Title: **QUALITY AUDIT**

**Road Safety Audit, Access Audit, Cycle Audit and Walking Audit.**

**Carlisle Residential Development, Kimmage Road West,  
Kimmage, Dublin 12.**

Report reference: **1383R01**

Drawing CST-BMD-00-ZZ-DR-C-1017 PL Rev 2, Main access road.

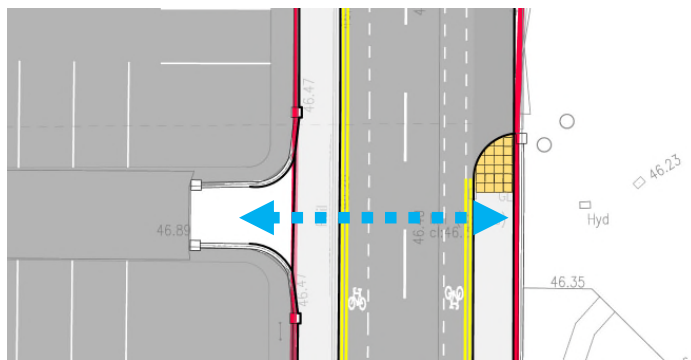
The main access road to the site is relatively straight and relatively long. This will lead to high vehicle speed and as a result high injury severity if a pedestrian or cyclist is struck by an errant vehicle. It was observed during the site visit that traffic calming measures are currently in place. It is unclear if these or similar are to be retained.

It is recommended that traffic calming measures be provided to ensure slow speeds.

Paragraph No. in Quality Audit Report	Problem accepted (yes/no)	Recommended measure accepted (yes/no)	Alternative measures (describe)	Alternative measures accepted by Auditors (Yes/No)
3.1	Yes	Yes		
3.2	Yes	Yes		
3.3	Yes	Yes		
3.4	Yes	Yes

Drawing CST-BMD-00-ZZ-DR-C-1017 PL Rev 2, Main access road, Start of shared use road.

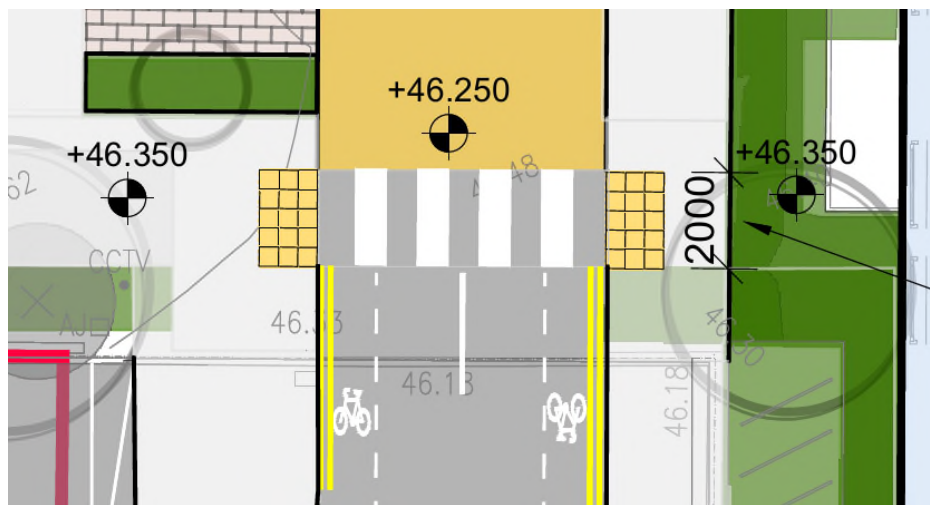
There is a proposed pedestrian crossing at the start of the shared use road. It has proposed zebra type black and white stripes which may lead to confusion over priority. Pedestrians may think that they have priority given the presence of the stripes but drivers may not think so due to the lack of flashing beacons. The confusion may lead to collisions between vehicles and pedestrians.

It is recommended that the stripes be removed and that an uncontrolled crossing be provided.

DRAWING REFERENCE  
CST-BMD-00-ZZ-DR-C-1017

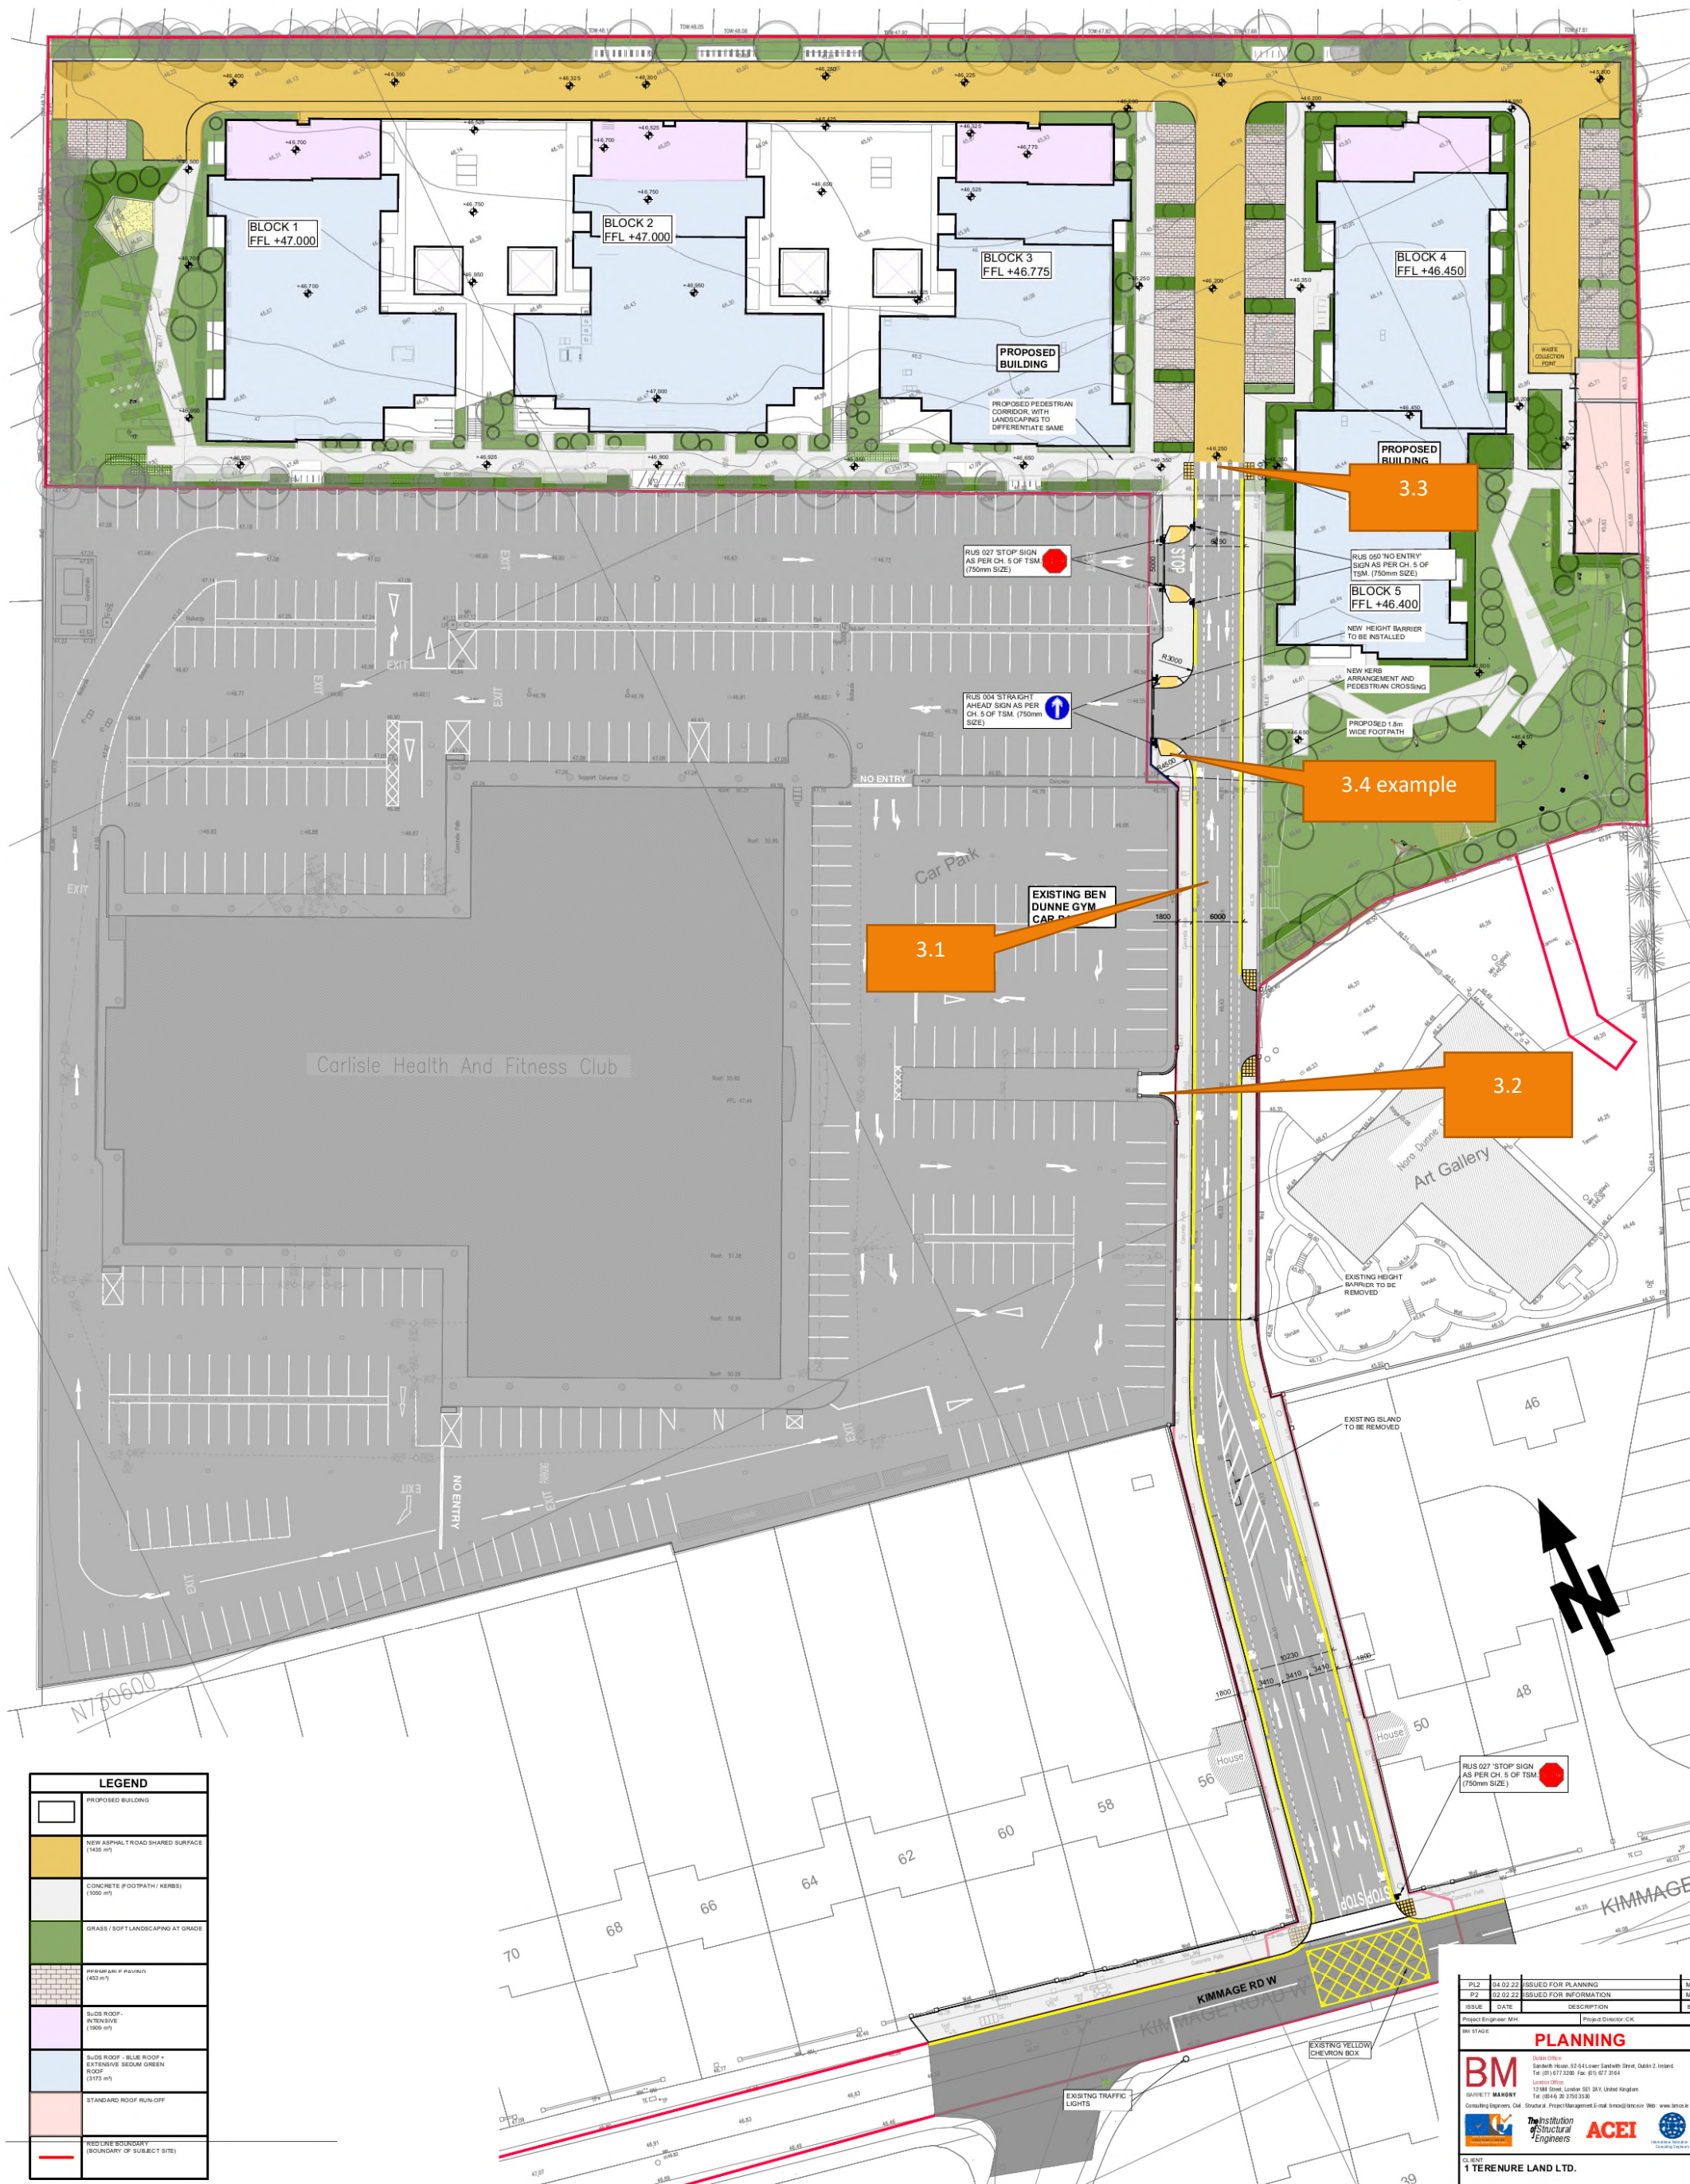
There will be a pedestrian desire line across the main access road to the pedestrian only access to the Ben Dunne Gym. Without dropped kerbs this could lead to trips and falls. It was noted during the site visit that there is a pedestrian guardrail on the footpath. It is unclear if it is proposed to retain the railing.

It is recommended that dropped kerbs and suitable tactile paving be provided to cater for the pedestrian desire line.
